Item ID: D350-607-511 Accept ***N900040100*** Setup Start ***NS1***
Revision ID:
Item Name: Quick Release Basket and Long Cargo Tube Mounting Provisions, Fits LH or RH Stop ***NS2***
Start Date: 11/4/2015 Start Qty: 2.00 ***2*** Cust Item ID:
Required Date: 11/12/2015 Req'd Qty: 2.00 ***2*** Customer:
Reference:

DART SERVICE INSTRUCTION

**TO AMEND INSTALLATION INSTRUCTIONS D350-607-3 Rev.D,
INSTALLATION INSTRUCTIONS D350-607-4 Rev. C AND
INSTRUCTIONS FOR CONTINUED AIRWORTHINESS ICA-D350-607 REV. 6**
REF TCCA STC: SH94-14
REF FAA STC: SR00213NY
REF EASA STC: EASA.10016996
REF BRAZILIAN STC: 2007S03-03/-04/-05/-06

A	NEW ISSUE	AJS	14.05.16
REV.	DESCRIPTION	BY	DATE
DESIGN	AJS	DART AEROSPACE LTD HAWKESBURY, ONTARIO, CANADA	
DRAWN	AJS		
CHECKED		DRAWING NO.	REV. A
MFG. APPR.	N/A	DSI 9699	SHEET 1 OF 2
APPROVED		TITLE	SCALE
DE APPR.		LUG REPLACEMENT	NTS
DATE	14.05.16	COPYRIGHT © 2014 BY DART AEROSPACE LTD THIS DOCUMENT IS PRIVATE AND CONFIDENTIAL AND IS SUPPLIED ON THE EXPRESS CONDITION THAT IT IS NOT TO BE USED FOR ANY PURPOSE OR COPIED OR COMMUNICATED TO ANY OTHER PERSON WITHOUT WRITTEN PERMISSION FROM DART AEROSPACE LTD.

FIGURE 1: INSTALLATION OF D4775-041 FWD STRUT

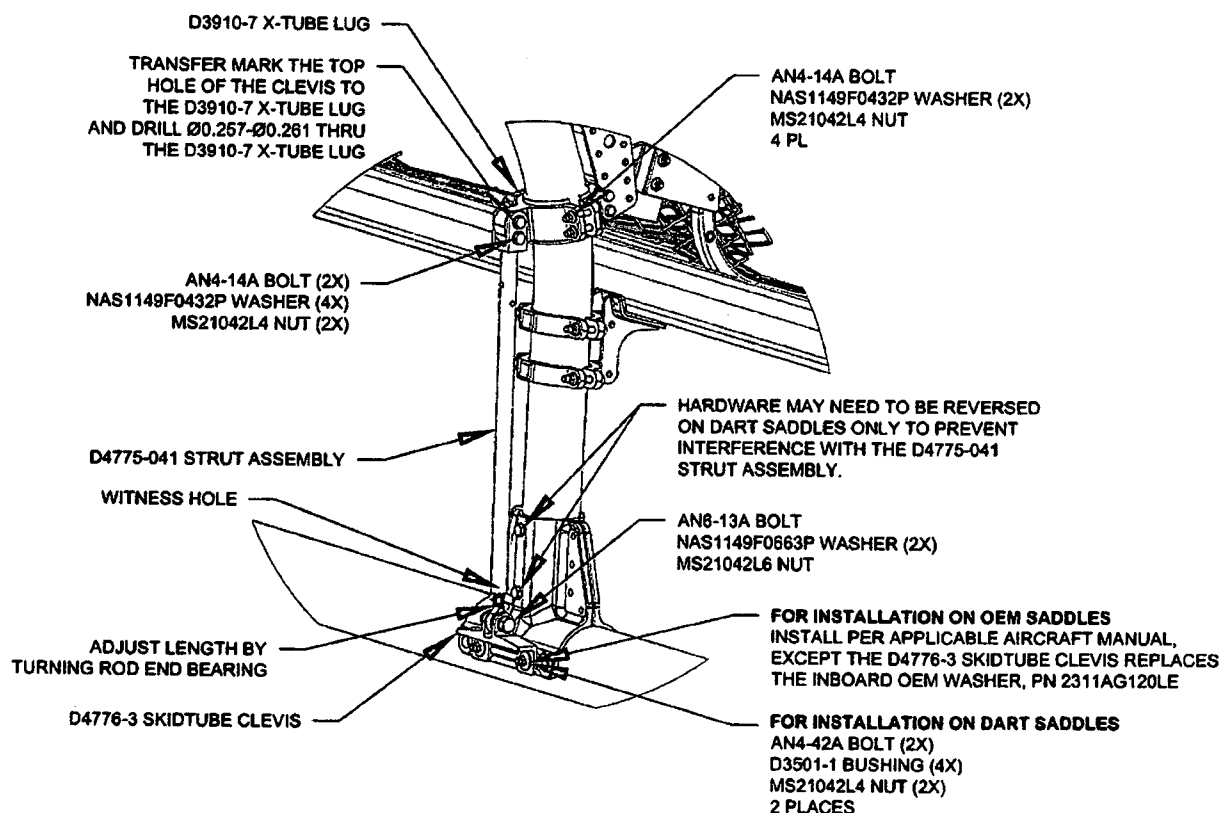
- 3.1 Substitute the Forward Lower D3910-5 X-Tube Lug with the D3910-7 X-Tube Lug as shown in Figure 1.
- 3.2 Install the forward D4775-041 Strut Assembly. Transfer mark from the upper hole on the clevis of the D4775-041 Strut Assembly to the D3910-7 X-tube Lug and drill thru the lug $\varnothing 0.257 - \varnothing 0.261$ as shown in Figure 1. Touch up chemical conversion coating per MIL-DTL-5541. Check the witness holes located at the bottom end of the D4775-041 Strut Assemblies to ensure that the thread from the rod end extends past the witness hole. **Torque MS21042L4/-4 nuts to 50-70 in-lbs (5.7-7.9 N-m). Torque MS21042L6/-6 nuts to 160-190 in-lbs (18.1-21.5 N-m).**
- 3.3 Complete the installation in accordance with Installation Instructions D350-607-3 Rev. D or D350-607-4 Rev. C.
